# **PRODUCT CHANGE NOTICE**

**Alternate Manufacturing Site  
for Assembly of the Listed  
Intersil SOT23 Packaged  
Products**

**Refer to:  
PCN13022**

Subject: **Alternate Manufacturing Site for Assembly of the Listed Intersil SOT23 Packaged Products – Carsem (CAM) Ipoh, Malaysia**

# PCN13022 – Current POD SOT23 5L

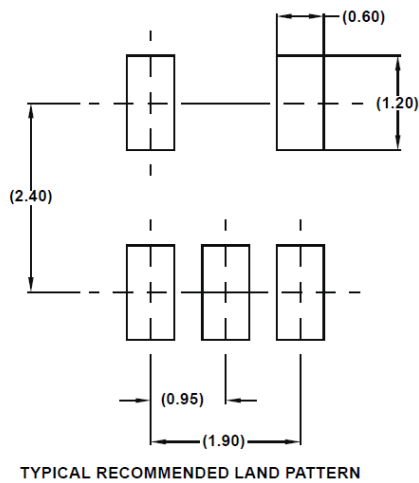
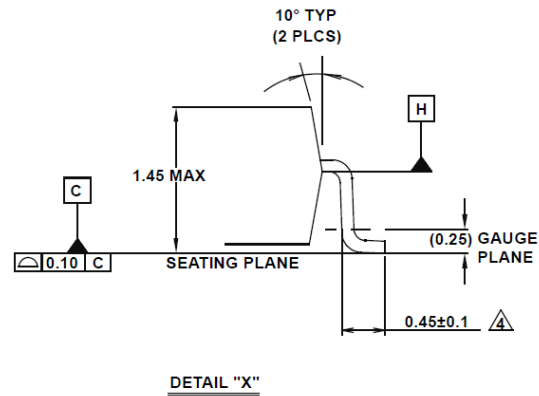
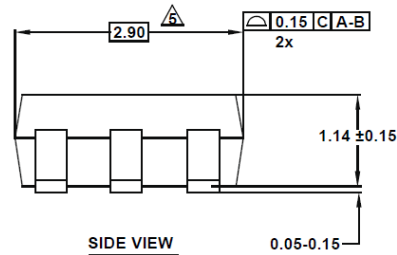
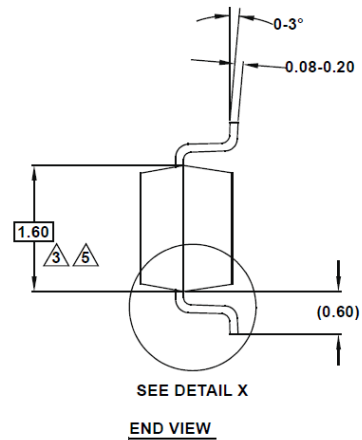
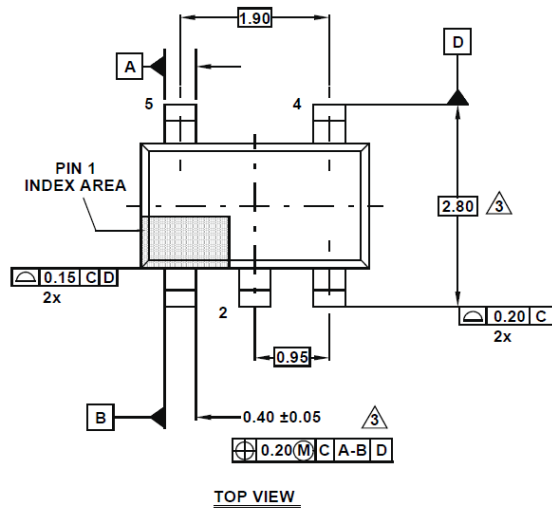
The Carsem (CAM) facility is ISO9001:2008, ISO/TS16949:2009 and ISO14001:2004 certified. The CAM facility is qualified as a supplier to Intersil for performing assembly of packaged products, including the SOT23 package style. There will be no change in the die attach, bond wire (material or diameter), frame material, or moisture sensitivity level (MSL). The packaged devices will require minor dimension changes to the package outline drawings (POD). However, there is no change in the recommended PCB land dimensions. The affected PODs and a summary containing a list of products along with the current and new PODs are included for reference.
